**TOWNSHIP OF McNAB/BRAESIDE
COMMITTEE OF ADJUSTMENT
AGENDA**

LAMORIE RESIDENCE - ACCESSIBILITY UPGRADES -

MINOR VARIANCE PLANNING REPORT

1. FILE NO.: A-7/24
2. APPLICANT: Robyn Lamorie and Nicholas Tourangeau (Owners)
Eugen Mihaescu (Agent)
3. MUNICIPALITY: Township of McNab/Braeside
(geographic Township of Braeside)
4. LOT:6 & Pt of Lot 7 Block: G Plan: 28 STREET: 953 Centre Street

1 FRONT PORCH PLAN - DEMOLITION & NEW WORK
MV2 1:50

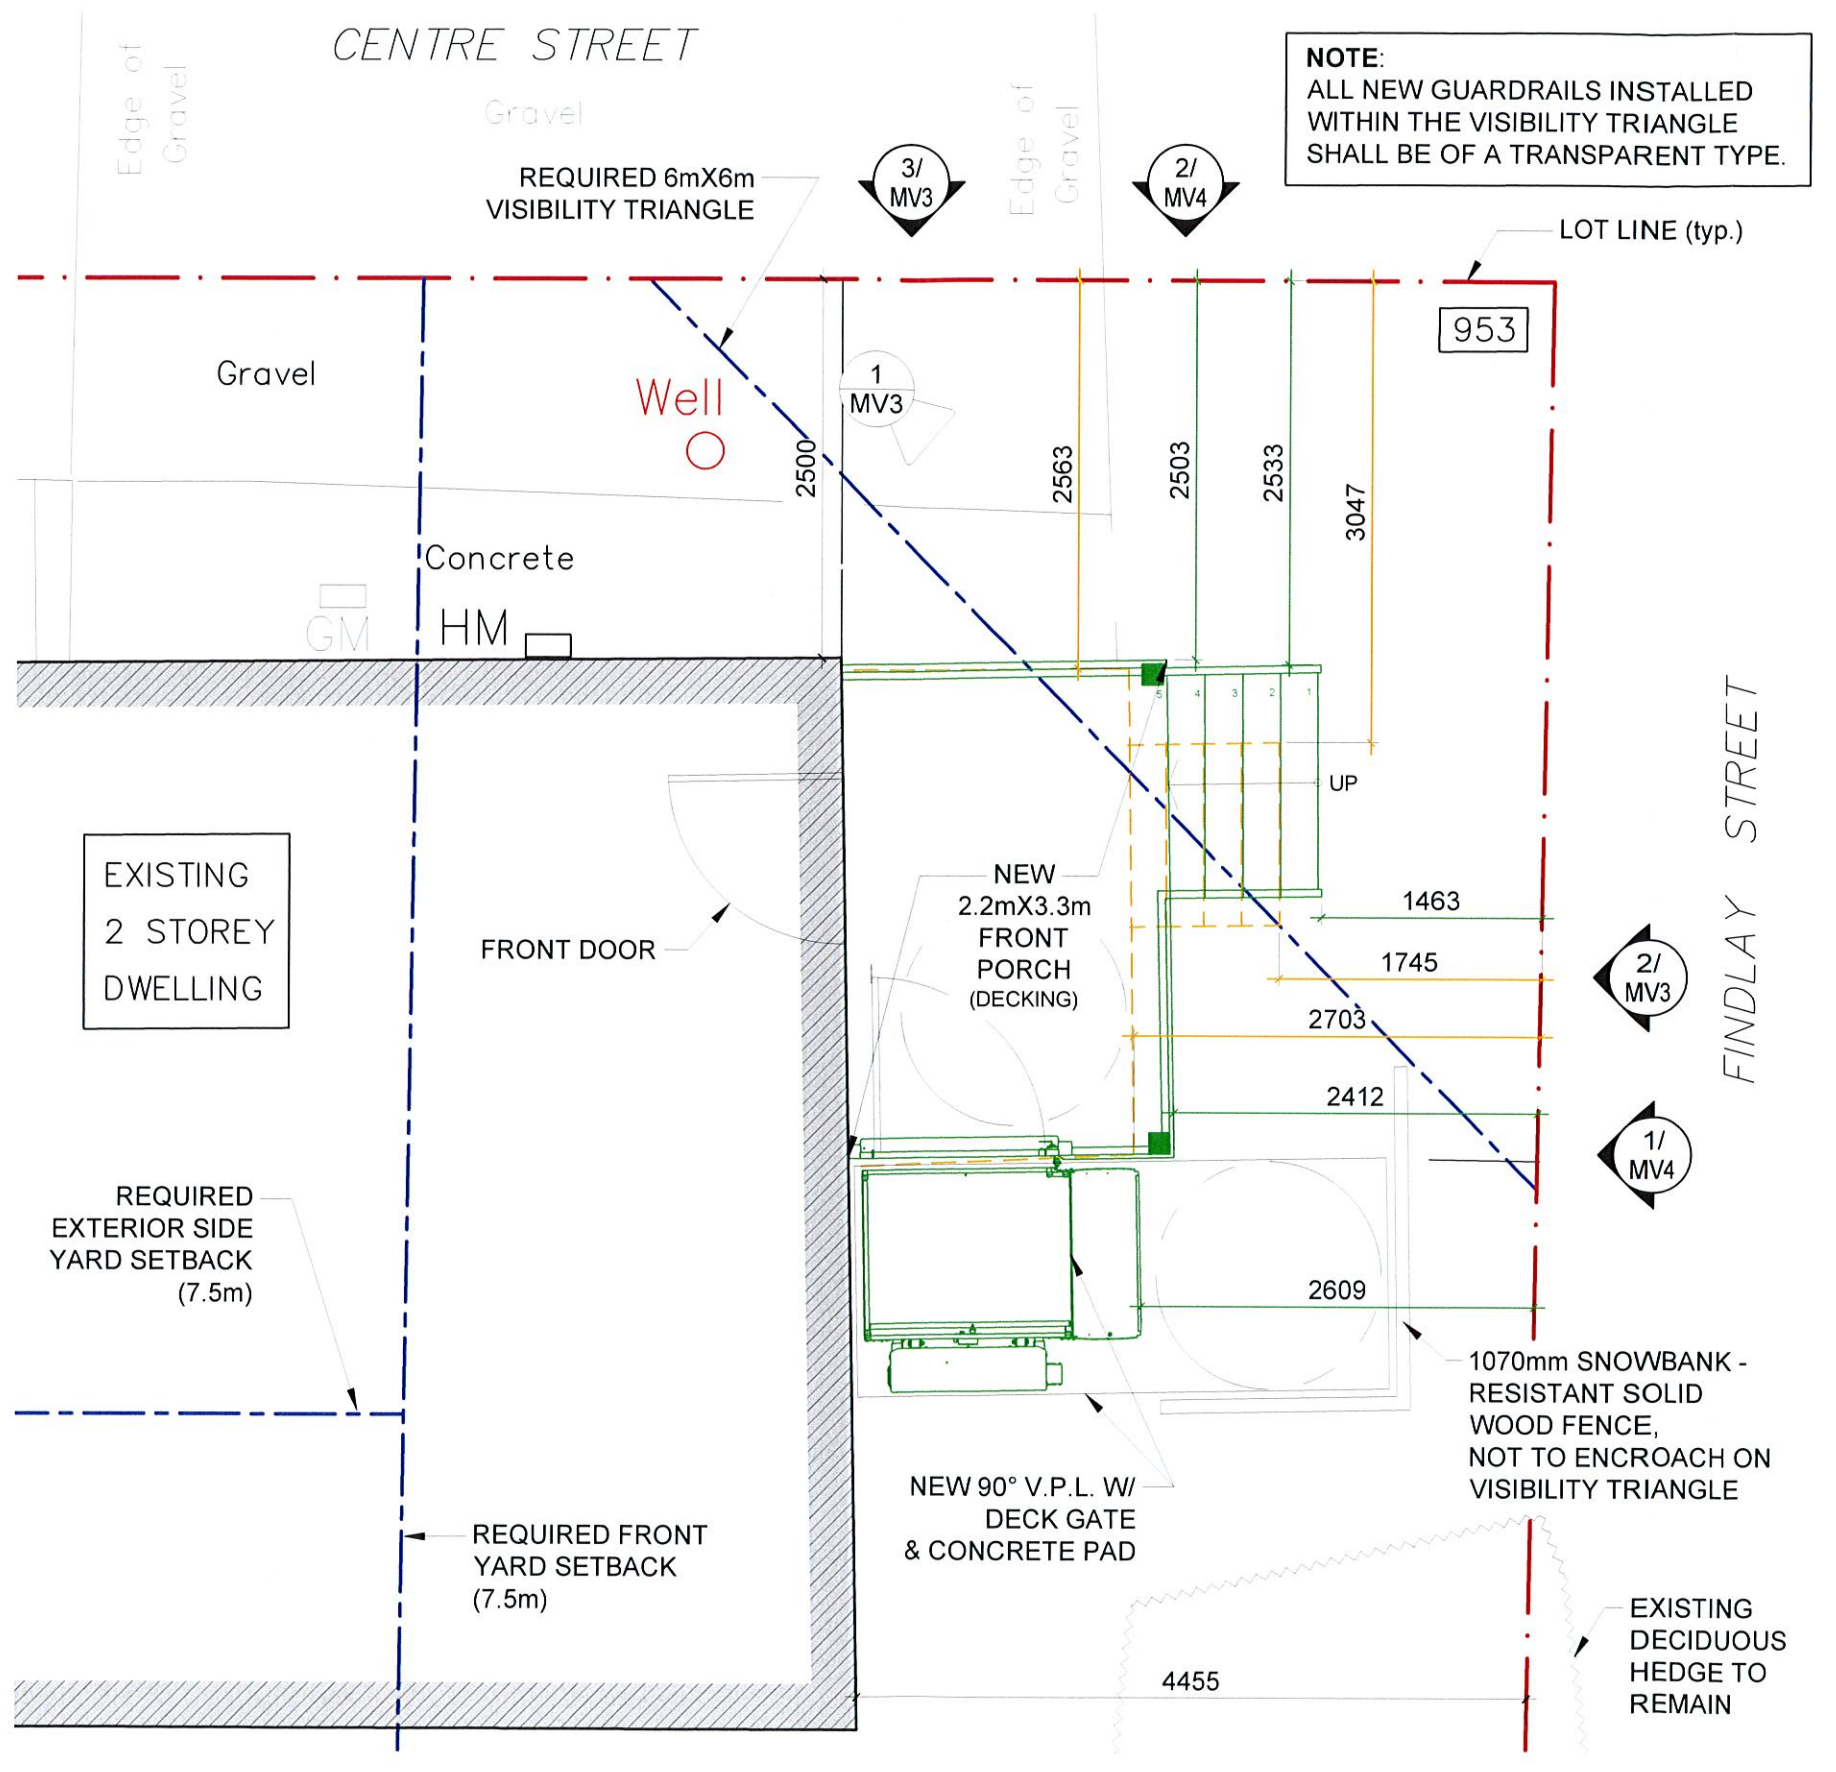
The application was also circulated to the Township of McNab/Braeside staff. Comments were received from Township on July 10th, 2024. The Director of Public Works has indicated that the Township has plans to reconstruct Findlay Street and Centre Street. It is recommended that the Township Public Works Department be contacted prior to setting grades for lift.

As the lot is on a corner, the Township cannot limit amount of snow distributed at the front of the property. The property owner can consider a barrier between the lift and the front lot line be installed to eliminate the risk of the lift being damaged by snow tailings from Township ploughs during the winter months. It is recommended that the public works consulted further at the time of the building permit.

It is further recommended, as described previously, that the property owner consult with the public works department regarding a snow barrier and the installation height of the lift at the time of a building permit.

- Existing Porch & Stairs (yellow)
- Proposed Porch, Stairs and Lift (green)
- Property Lines (red)

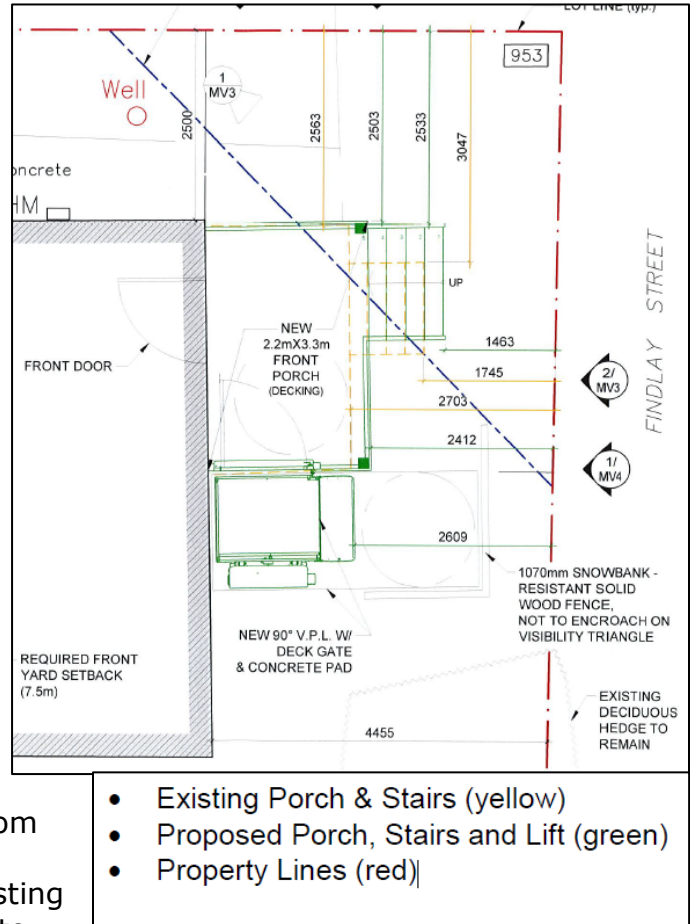
The existing dwelling is situated at the east corner of the lot. The proposal is to construct a front porch to accommodate a new Vertical Platform Lift (VPL) in the existing non-complaint front yard off Findley Street. The proposed replacement would be at the same location however slightly larger than the existing porch, which is negligible (see right).

The proposed application requests a variance to reduce the front yard setback down to 2.4 metres and 1.4 metres, respectively for the porch and stairs; and Lift 2.6 metres. Also, requests a variance to reduce the side yard setback down to 2.5 metres and 2.5 metres, respectively for the porch and stairs.

Also, increases the height of front porch deck and stairs to 0.95 metres from required 0.75 metres, which is small increase and considered minor. The existing house meets the setback requirements to the rear lot line and interior side yard depth; however, it does not meet the required front yard and exterior side yard of 7.5 metres.

Based on this, the variance can be considered minor.
